SERVICE BULLETIN

APPLICABILITY: 2019-20MY Forester
SUBJECT: B-Pillar Trim- Design Change

NUMBER: 12-294-20
DATE: 05/28/20

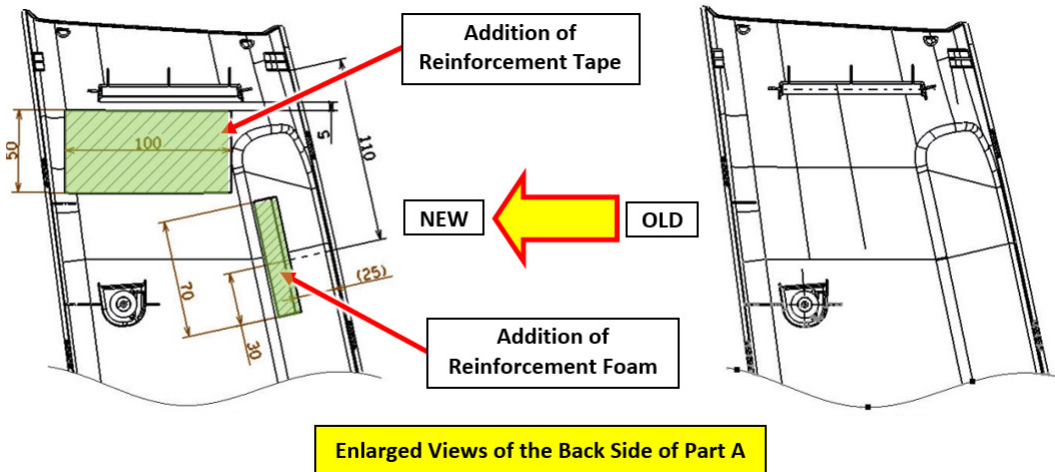
This bulletin announces a design change made to the B-pillar trim. The change prevents the trim's appearance from deteriorating as a result of recurring contact with the steel latching tongue portion of the seat belt. Over time, the color of the trim can begin to whiten from being repeatedly hit by the tongue after releasing the latch and letting go of the belt when exiting the vehicle. The new trim is slightly softer requiring reinforcing materials to be added to the back side to optimize strength of the part as shown in the illustration below.
